Access Compliance Report

Public Rights-of-Way

Intersection ID: 29226	Main Street: KORNIV_DR	Cross Street: ROZUMNY_DR	Location: SW
ADA ID: F15729F86FB0	Ramp Type: PerpDiag	Initial Pass/Fail: Pass	Overall Compliance: No
Severity Score: 7.75			
Codes/Mitigation Info/Possible Solution		Field Measurements/Component Compliance

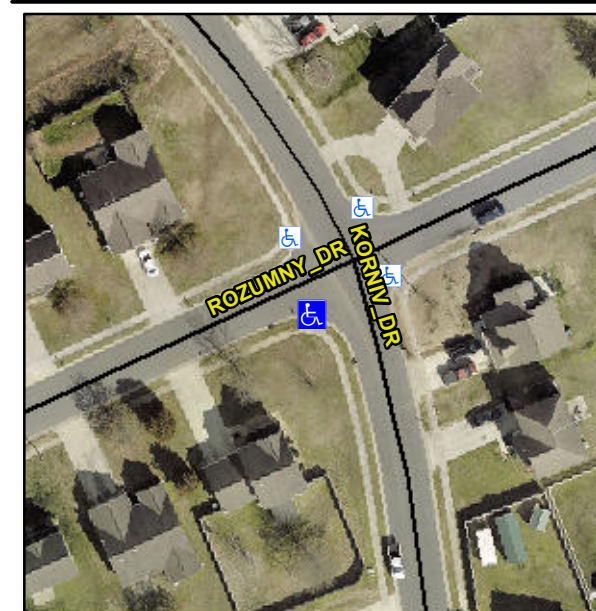
Not Found, R304.5.3, R304.2.1, R304.2.2-Perp, R304.3.2-Para, R305.1.4, R305.2, R304.5.4

Compliance	Description	Data	Compliance	Description	Data
N/A	Ramp Length (in)	49.5	Yes	Ramp Slope (%)	7.7
Yes	Ramp Width (in)	63.0	No	Ramp XSlope (%)	3.6
N/A	Flare Type LT	Sloped	N/A	Flare Type RT	N/A
N/A	Flare Slope LT (%)	7.5	Yes	Flare Slope RT (%)	4.1
N/A	Flare Traversable LT?	Yes	N/A	Flare Traversable RT?	Yes
No	Landing Length (in)	42.0	Yes	DWS Provided?	Yes
Yes	Landing Width (in)	49.0	Yes	DWS Contrast?	Yes
No	Landing Slope (%)	3.6	Yes	DWS Length (in)	24.5
No	Landing X Slope (%)	3.0	No	DWS Full Width?	No
N/A	Landing Curb? (Y/N)	No	No	DWS Offset (in)	3.0
N/A	Shared Landing?	No			
Yes	Gutter Ponding?	No	No	Gutter Slope (%)	6.1
Yes	Gutter Lip Ht (in)	0.0	Yes	Gutter X Slope (%)	0.4
N/A	Painted X Walk1?	No	N/A	Painted X Walk2?	No
	X Walk 1 Direction	To E		X Walk 2 Direction	To N
N/A	X Walk 1 Width (in)	N/A	N/A	X Walk 2 Width (in)	N/A
	X Walk 1 Slope (%)	2.3		X Walk 2 Slope (%)	1.9
	X Walk 1 X Slope (%)	3.3		X Walk 2 X Slope (%)	1.3

Remove & Replace Curb Ramp With Two New Directional Ramps or Equivalent. Remove & Replace Gutter.
